Subject: AP1000 Response to Request for Open Item (SRP 3)

Response to Request for Additional Information on SRP Section 3

AP1000 TECHNICAL REPORT REVIEW

RAI Response Number: RAI-TR09-008

Figure 6.2.1.1-11 AP1000 External Pressure Analysis Containment Pressure vs. Time

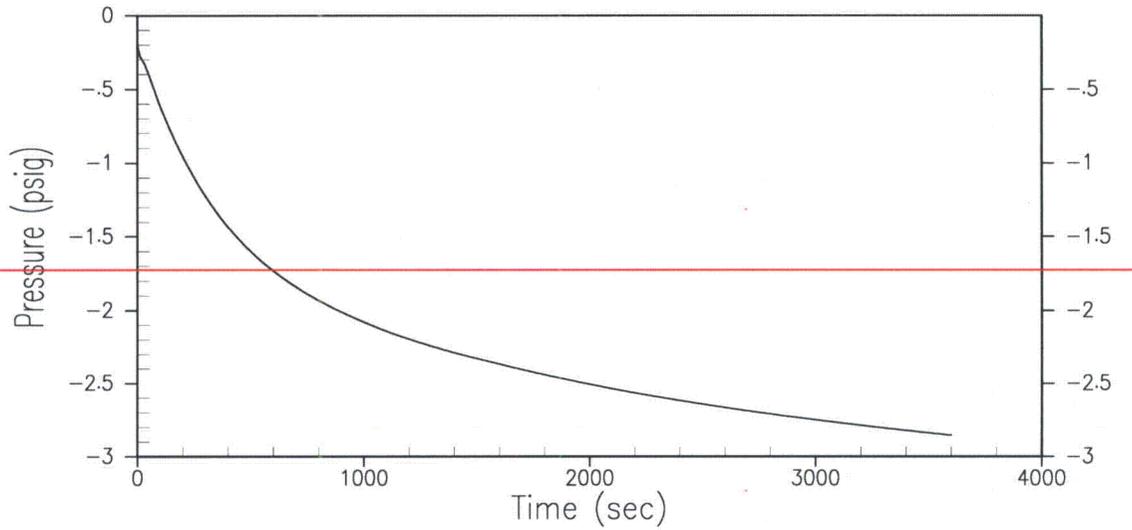
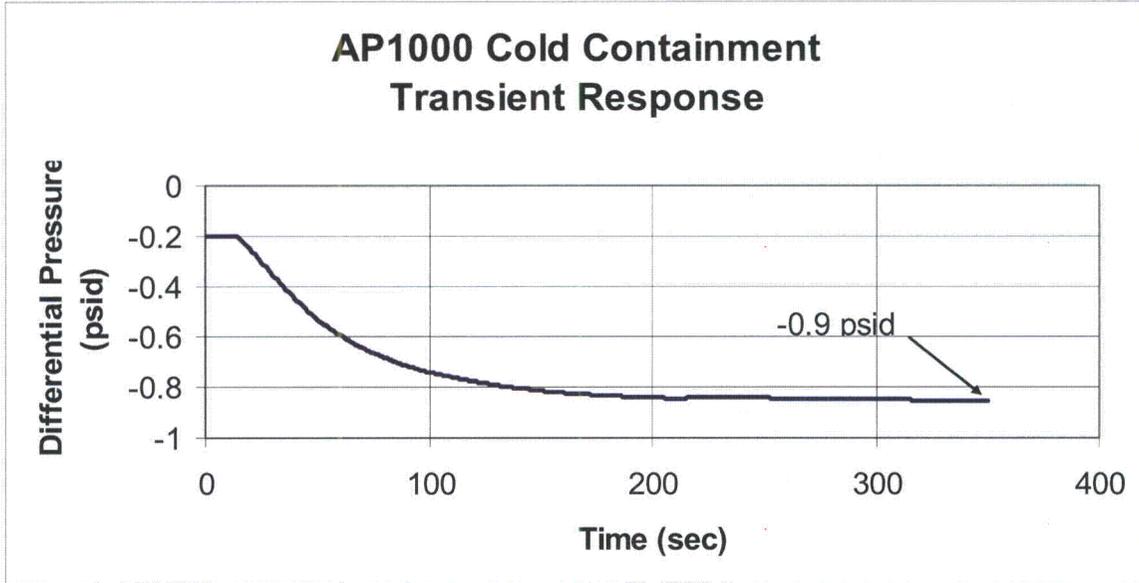
The following revisions to Subsection 6.2.1.1.4 and Figure 6.2.1.1-11 were provided in Revision 2 of this response. Please see the response to RAI-SRP6.2.1.1-SPCV-07 Revision 1 and 2 for more recent revisions to this subsection. RAI-SRP6.2.1.1-SPCV-07 Revision 2 modifies Subsection 6.2.1.1.4 to be similar to the description in DCD Revision 15.

For consistency with Figure 6.2.1.1-11, the words 'at one hour' were deleted from the text in section 6.2.1.1.4 of the DCD, Revision 16. This change and all other DCD changes shown below were incorporated in Revision 5 of APP-GW-GLR-134 (Technical Report 134).

Certain design basis events and credible inadvertent systems actuation have the potential to result in containment external pressure loads. Evaluations of these events show that an inadvertent actuation of active containment cooling ~~a loss of all ac power sources~~ during extreme cold ambient conditions has the potential for creating the worst-case external pressure load on the containment vessel. This event leads to a ~~reduction in the internal containment heat loads from the reactor coolant system and other active components, thus resulting in a~~ temperature reduction within the containment and an accompanying pressure reduction. Evaluations are performed to determine the maximum external pressure to which the containment may be subjected during a postulated actuation of the active containment cooling ~~loss of all ac power sources~~.
